**MONTGOMERY COUNTY PLANNING DEPARTMENT**  
THE MARYLAND-NATIONAL CAPITAL PARK AND PLANNING COMMISSION

**REVISED Staff Report: Site Plan 820080180 North Bethesda Center, Parcels A and C, and Infrastructure**

**DATE:** July 24, 2008  
September 11, 2008

**REPORT DATE:** March 24, 2008  
August 29, 2008

*Site Plan*

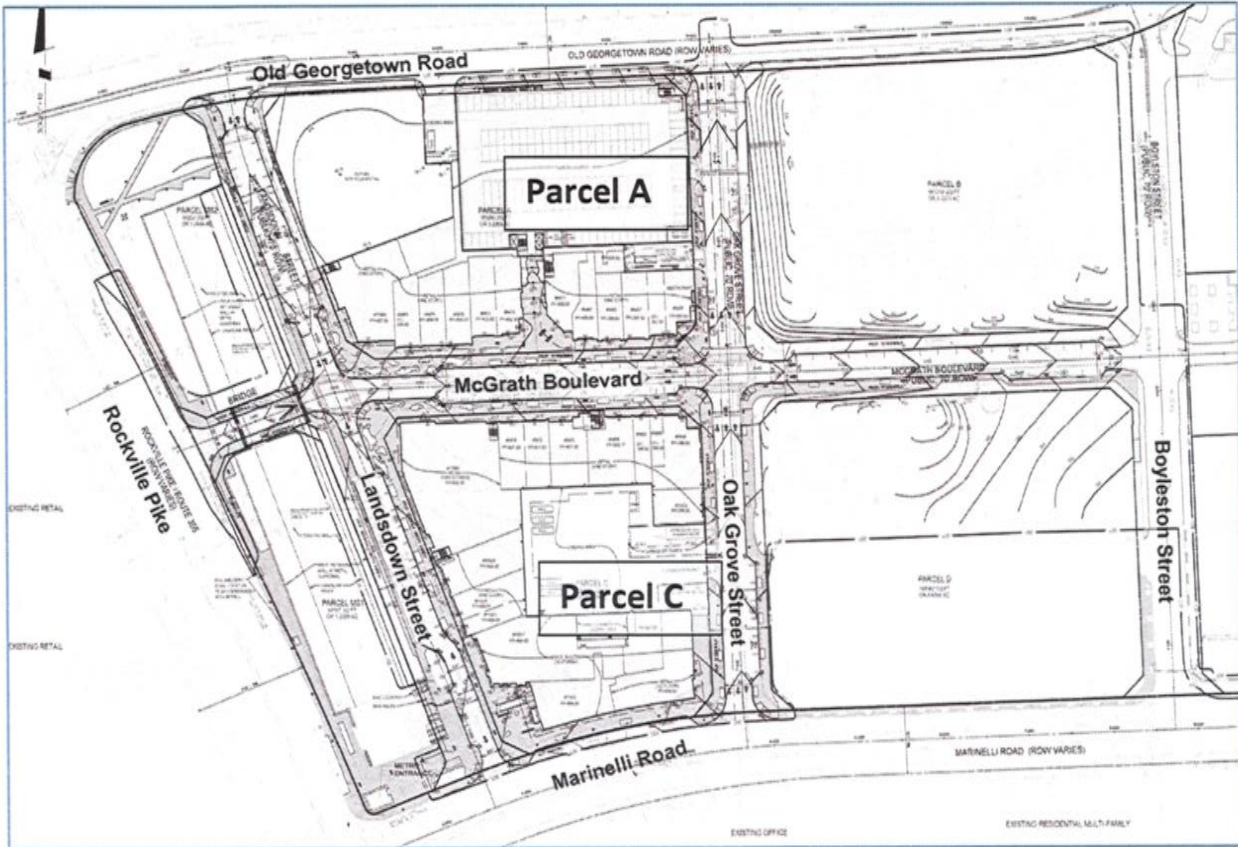
The Applicant's proposal consists of 352,622 gross square feet of commercial office uses and 175,033 gross square feet of retail uses, including a 320-seat below-grade movie theatre, to be distributed between Parcels A and C. Part of Parcel A, at the intersection of Old Georgetown Road and Landsdown Street, has not been included with this application for a future proposal. Parcel A provides 698 parking spaces in a structured garage at the corner of Old Georgetown Road and Oak Grove Street. Parcel C provides over 1,000 parking spaces below grade. Both of these parking facilities will be accessed from Oak Grove Street.

Site Plan Detail (w/ 14-story Building Highlighted)

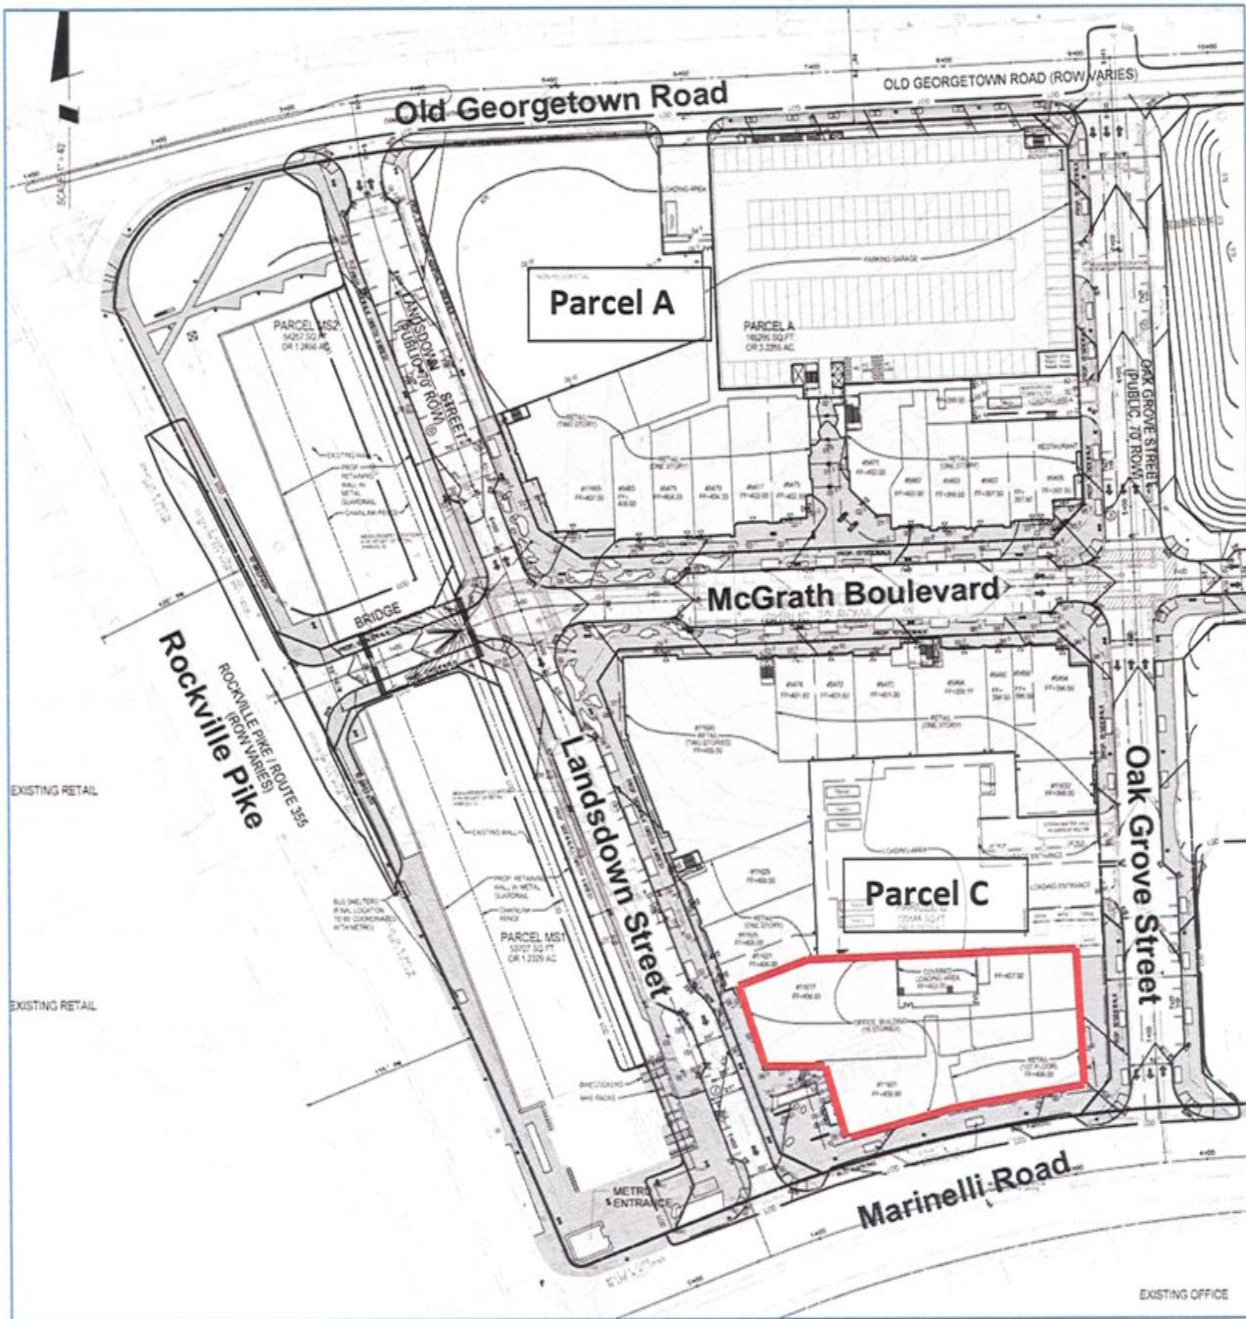
The bulk of the commercial space is located within an 14-story office building at the corner of Landsdown Street and Marinelli Road, outlined in the Site Plan detail below. The remaining retail and commercial square footage is located in one-story buildings, with two-story buildings at the intersection of McGrath Boulevard and Landsdown Street.

Staff has reviewed this application and the elements proposed with this Site Plan and contends that the application does not satisfy the finding needed to support the Site Plan.

As proposed, this Site Plan for Parcels A and C, comprised of the buildings fronting directly onto Rockville Pike, does not meet the expectations of the District Council as stated in their approval. This project places relatively little building height and density along the primary frontage for Rockville Pike, locating primarily one- and two-story buildings where significantly taller buildings should be, with only one 14-18-story office building on the southern edge of Parcel C. The low buildings along this main thoroughfare will not create the image of a single urban node of redevelopment in a new urban center, but will only reinforce the existing automobile-oriented sub-urban development patterns along Rockville Pike.

Nor will these highway-retail-scale buildings visually link the east and west halves of the White Flint District. The taller buildings at the intersections of Landsdown Street with Old Georgetown Road and Marinelli Road will begin to relate to the taller buildings north and south of the site. But the dramatic drop in building height and scale at the center of the block, especially along the “main” axial and retail streets, McGrath Boulevard and Landsdown Street, will seem anachronistic in their lack of urban center place-making.

building, in the proposed Site Plan will create an automobile-oriented development that is inconsistent with the promotion of adequate and efficient pedestrian circulation. A more adequate and efficient development would include a base of at least five- or six-story buildings, with accent buildings in the form of residential or commercial towers up to twenty stories, and will clearly define the public space that creates an urban town center. As proposed, the location of the buildings and structures, open spaces, landscaping, and pedestrian circulation systems is not adequate or efficient.

3. Site Design
  - a. All buildings must have a minimum parapet height or architectural base reading of 25 feet, measured from the sidewalk along the street frontage at each building entrance;

- b. The above-grade parking structure on Parcel A must present a pedestrian-friendly design, to include pedestrian entrances on each facing street and a minimum two-story architectural base, measured from the sidewalk in front of each building facade;
